Kino to DMP Transmission Line Project

CWG Questions and Responses		
No.	Question	Response
104	<p>I wasn't sure of the best way to provide feedback so I thought I would just send you a note. I thought last night's CWG meeting worked very well. For that type of meeting, doing it as a Zoom Webinar was as effective for me as being in a large room all together and it had the added benefit of not having to take the time to drive to and from the event.</p> <p>I thought the format of stopping to vote on and answer questions was effective and helped keep the meeting on schedule. All three of you were articulate, knowledgeable, and professional.</p> <p>In the future, even after large group meeting restrictions are lifted, I would still support this format.</p> <p>I did have one question that I neglected to ask (and can post it elsewhere if you prefer). You seemed to have 3 different ways of representing the scoring data.</p> <ul style="list-style-type: none"> - Pages 20-22 show a color coded scoring based on comments (page 21) and a composite of that with constructability (page 22). - Page 24 shows a color coded constructability score. - Pages 69 thru 79 show a color coded composite scoring

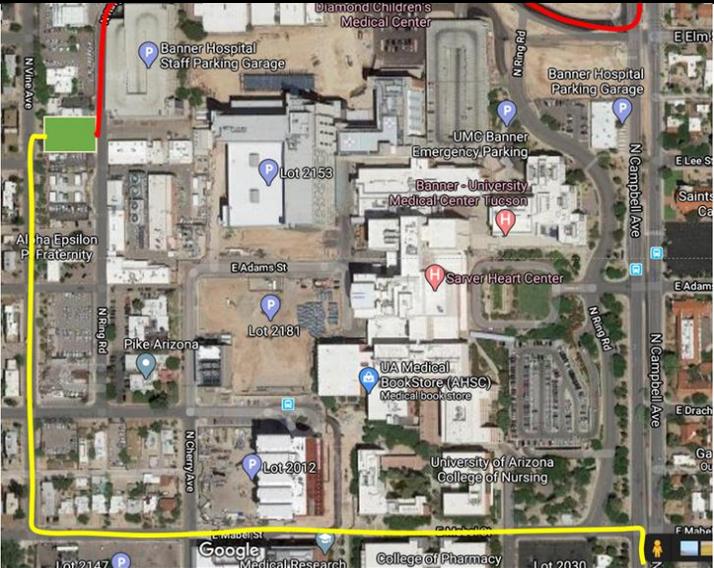
CWG Questions and Responses		
No.	Question	Response
107 Cont.		<p>6) Two blocks east of Vine is a school...was that considered as a sensitive spot for corridor A? No, it does not influence Vine, as it is outside the 300 foot buffer. It does however influence Route D, on Campbell as can be shown in the figure below.</p> <p>7) The association letter was regarded as one comment on Vine and Park, but please see #3 above. We reiterate that there is no voting in this process. Jefferson Park residents have most definitely been advocating individually and we welcome additional comments.</p> <p>8) Thank you for the feedback.</p>
108	<p>I see from the signs that the power poles issue is still going on. I had some ideas about that, based on my 50+ years of professional technical experience (electrical engineering, geophysics, reliability engineering / physics of failure, project management.)</p> <p>The gas company ran the high pressure gas line down Lester in front of my house to Vine, where it made a right angle turn to go south toward the university power station. The power company is proposing, it appears, to bring their 138 Kv power poles east to Vine and then south and/or north. In 1887, Tucson was damaged by an earthquake caused at the Pitaycachi fault zone south of Douglas. Eventually, we will have another, perhaps from the Santa Rita fault zone south of Green Valley, much closer to Tucson. Estimates from the University (Arizona Geological Survey) indicate that such a quake could be as high a magnitude of 7.0. KVOA had a news video on this in 2015.</p> <p>It is likely that the maximum stress the high pressure gas line on Lester would experience during the earthquake will occur where the pipeline makes that right angle turn to go south at Vine. So, it is possible to have a high pressure gas leak at that point, during an earthquake. There are likely some automated safety features used by the gas company to control gas leak damage, that may or may not work correctly during an earthquake. If an earthquake caused mechanical failure with the insulators on the 138Kv power pole lines adjacent to Lester & Vine, there would be the possibility of an electric arc occurring in the same vicinity of the earthquake caused high pressure gas leak below it. The result would be catastrophic.</p> <p>☒</p>	<p>Thank you for your response and insight, this is a very interesting topic. We appreciate and recognize your concerns. TEP would like to point you to a study conducted by FEMA (FEMA-202 / September 1990) which states "Records from past earthquakes indicate that electrical transmission lines are not very vulnerable to earthquake damage".</p> <p>Should the gas line experience a failure, the gas will remain low to the ground and has a higher chance of being ignited by either a pilot light within a home or by a spark from falling debris that would occur during an earthquake.</p> <p>The 2011 Christchurch earthquake that occurred in New Zealand caused damage to approximately 220 miles of underground transmission lines while overhead transmission lines remained relatively intact with the exception of a few miles where liquefaction of the soil occurred.</p> <p>Regarding the requested study, both the electric and gas utilities are under the oversight of the Arizona Corporation Commission (ACC) and TEP would rely upon the ACC to determine and issue the need for such a study to be conducted. ☒</p>
